GMU Project 17-206-02
Permit No. PKG21-0490

Subject: Response to County of Orange Geotechnical Review Comments Pertaining to Precise Grading Plans, Dana Point Harbor Revitalization, Buildings 1 through 12, Commercial Component, City of Dana Point, California

RESPONSES TO GEOTECHNICAL COMMENTS

Figure D-2

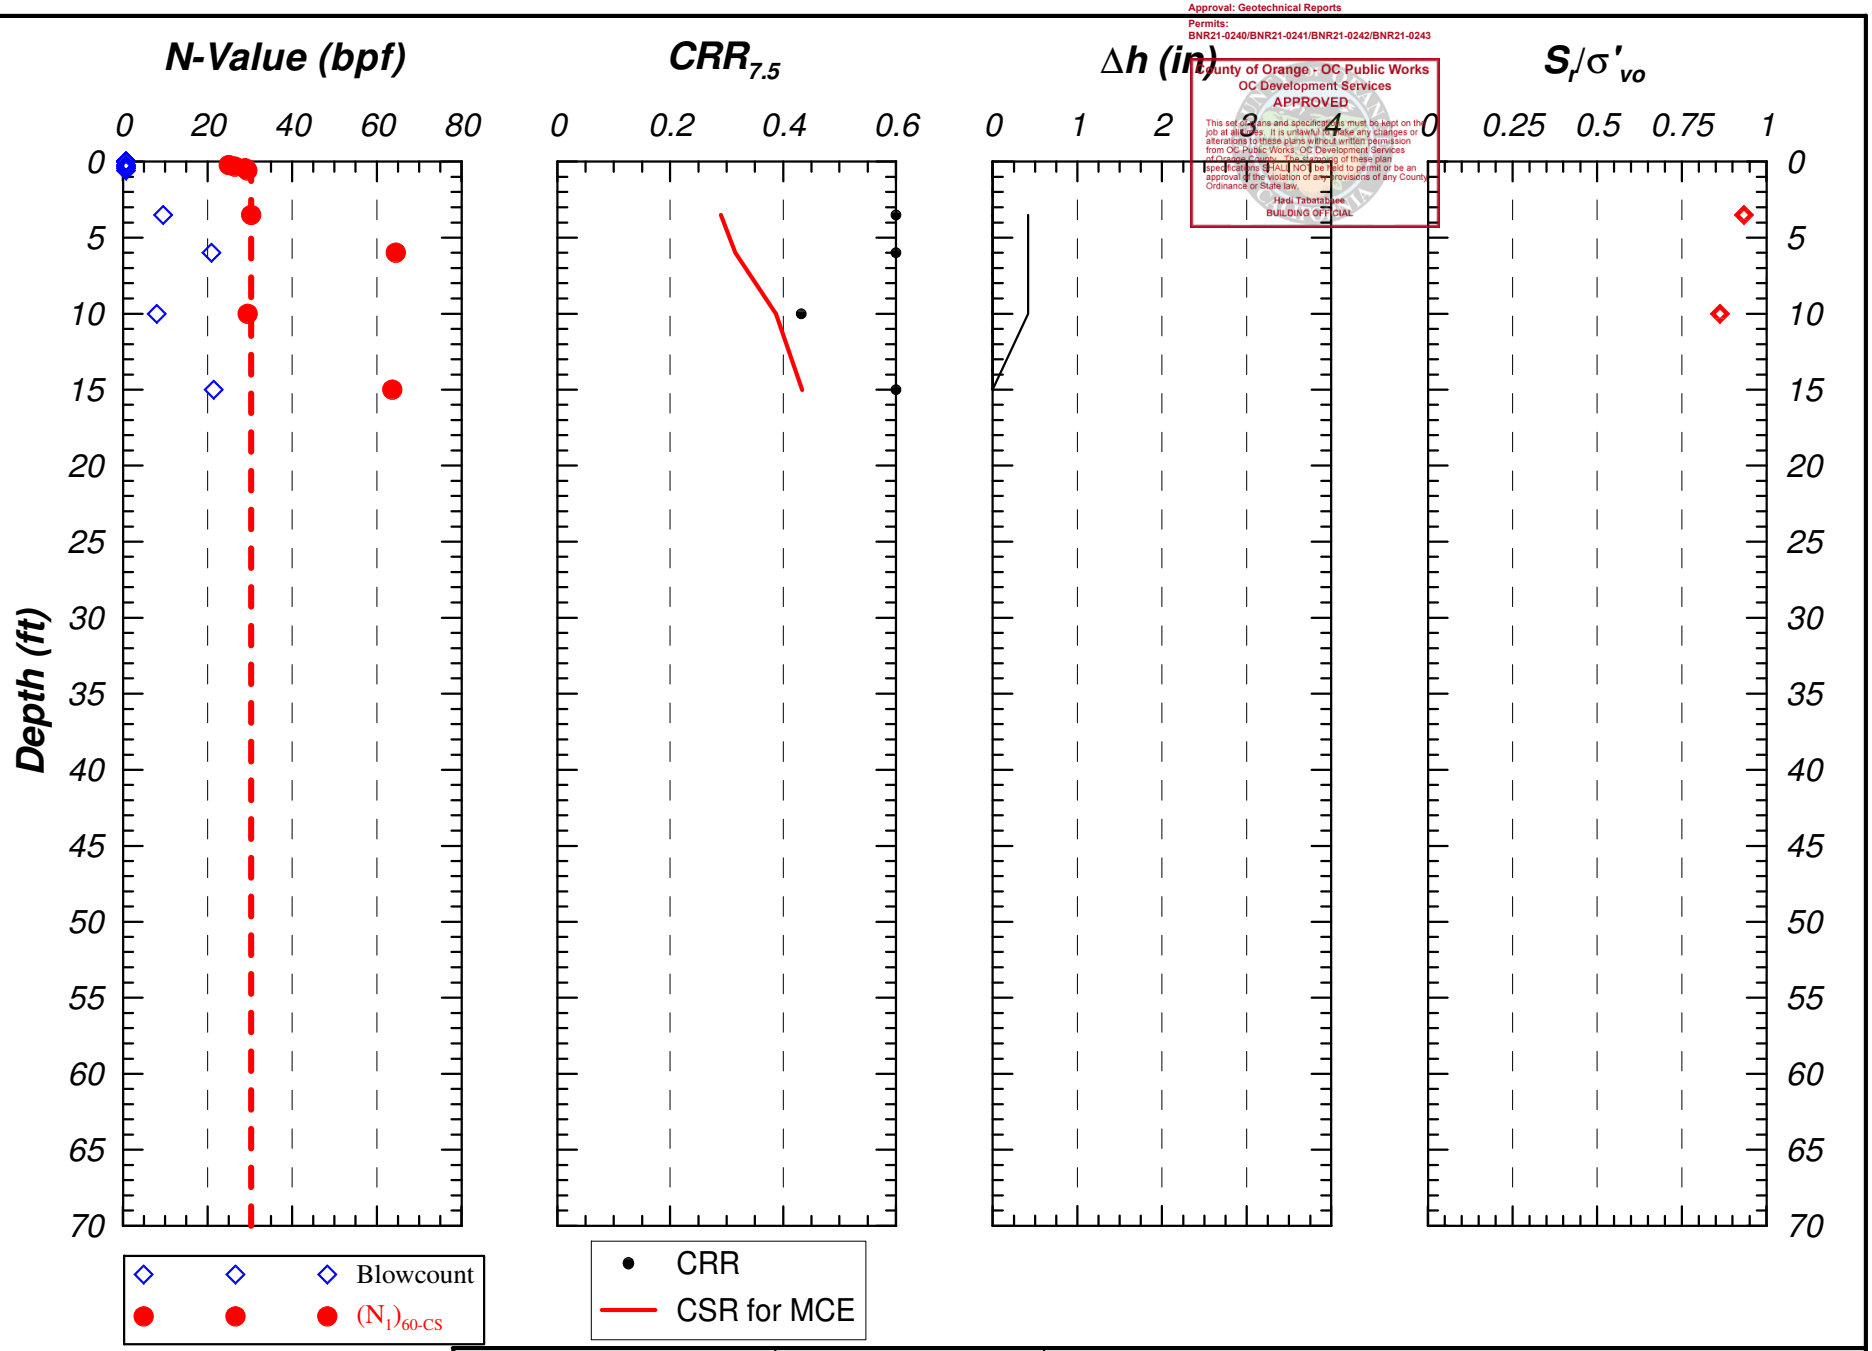
The submitted geotechnical report (GMU Geotechnical, Inc., dated 5/27/21) indicates that liquefaction analysis was performed on the SPT exploratory data as a cross-check to the CPT liquefaction analysis and yielded similar results. Please provide a copy of the completed SPT liquefaction analysis as discussed in the submitted report. Provide additional recommendations as needed.

Results of the liquefaction analysis performed on SPT data of six (6) exploratory borings (DH-12, DH-17, DH-18, DH-19, DH-26, DH-51) are included as Appendix B. As stated in the submitted geotechnical report, CPT-based liquefaction analyses provide a more reliable, accurate and continuous database from which to calculate liquefaction magnitude. The SPT-based analysis was generally consistent with the results of the CPT-based analysis, but it does include a few isolated cases indicating a larger magnitude of settlement, which is not uncommon using SPT-based analysis. We do not believe these aberrations are accurate predictions of the expected earthquake-induced settlements under the considered ground motions.
